Ann Collins

Re: New The Forest High School - Application No: SSD-26876801

Location: Lot 6 & Lot 7 DP 1280781, Lot 750 & Lot 751 DP 1271174, Allambie Road, Allambie Heights (formerly 187 Allambie Road)

Figure 12: Northern beaches High Quality Catchments Map (Source: NBC Water Management for Developments Policy)

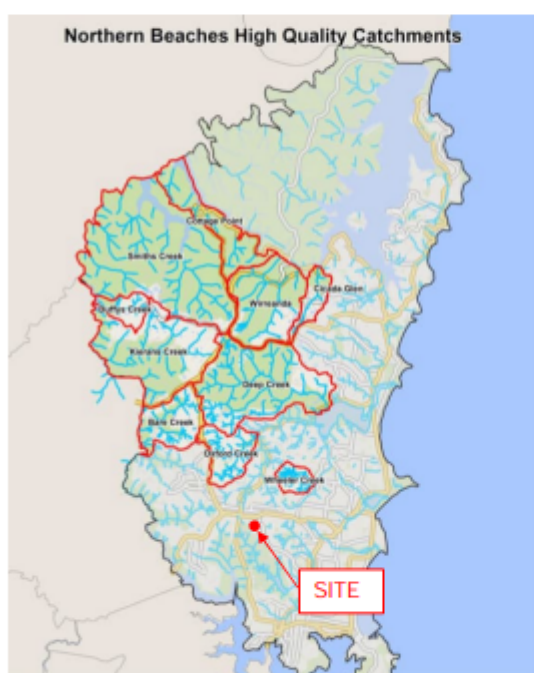
Additional Comments re Drainage & Stormwater - Lessons learnt and mistakes made at Manly Vale Public School must not be repeated here. **This site is within a NBC High Quality Catchment** – this report has been updated. The stormwater should be NORBI compliant.

The NBC Water Management for Developments Policy sets out the requirements for treatment of the stormwater prior to discharge into the Council system. The site is not located within a NBC High Quality Catchment (Figure 12). As the total site area is comprised of various Lots, there are separate requirements for each. The proposed Lot 11 and 12 satisfies the NBC category of "undeveloped land" which will require pollutant targets at shown in Figure 13. The existing Lot 11 is required to follow Figure 14 pollutant requirements. The stormwater is discharging to Manly Creek to the south of the site which connects to the Manly Dam, requiring stringent stormwater treatment.
